100954 Top Wighay Farm, Hucknall

Drainage & Flood Risk Review

REPORT REF: TWFH-DCE-XX-XX-RP-C-0001

Client: Linby Parish Council

Figure 3 - Environment Agency Flood Mapping – Risk of Flooding from Surface Water, Edited

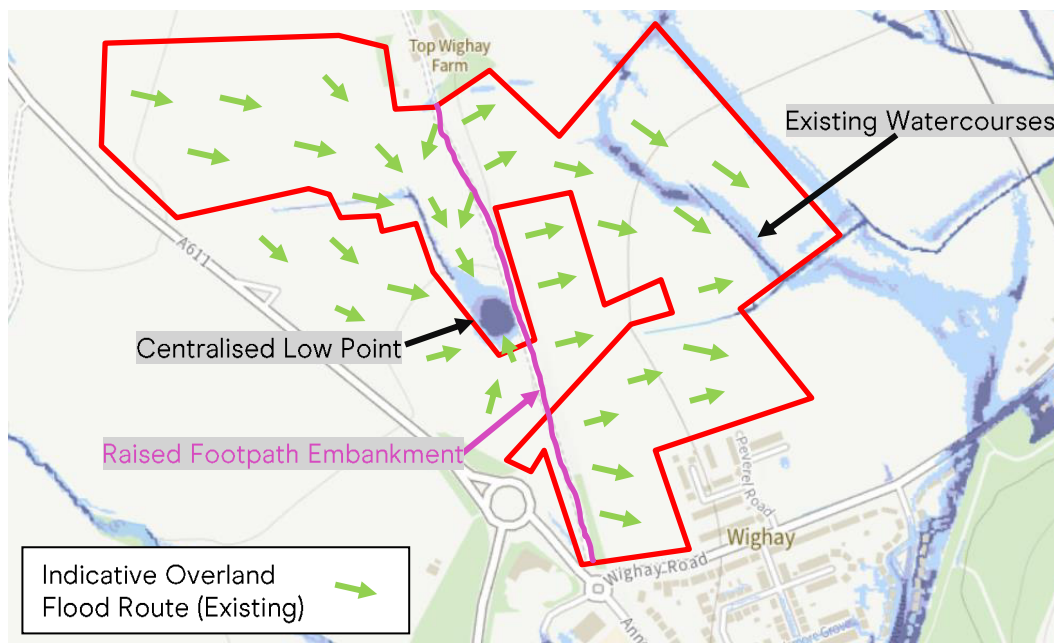
The Environment Agency Risk of Flooding from Surface Water mapping for the site area is shown in **Figure 1** below. The map indicates several hot spots of low to high flood risk throughout the site, predominantly where the watercourses are present, which is not uncommon. There is however a centralised spot of high flood risk in the middle of the site. From reviewing the topography and pre-development flood route path, this area looks to collect a large amount of existing runoff, with no positive outfall. This means that this hotspot likely stores and infiltrates a large portion of the site's existing runoff.

Area A covers a significant portion of the site at 11.23ha, therefore having a calculated existing greenfield runoff rate of 33.3l/s. This runoff is directed along the existing overland flood route, indicated in **Figure 1**, towards a centralised low point with no confirmed positive outfall. The BSP FRA (2.) states this low point is currently served by a drainage ditch with a positively drained pipe, however, there remains insufficient evidence to confirm if this is the case or where the pipe ultimately discharges to. This means that the directed rainfall runoff collects within this centralised low point, as shown on the Environment Agency's surface water flood maps. Once at the low point, surface water is most likely stored and infiltrated over time, unless the outfall pipe mentioned can be traced to confirm connection to one of the watercourses within or surrounding the site.
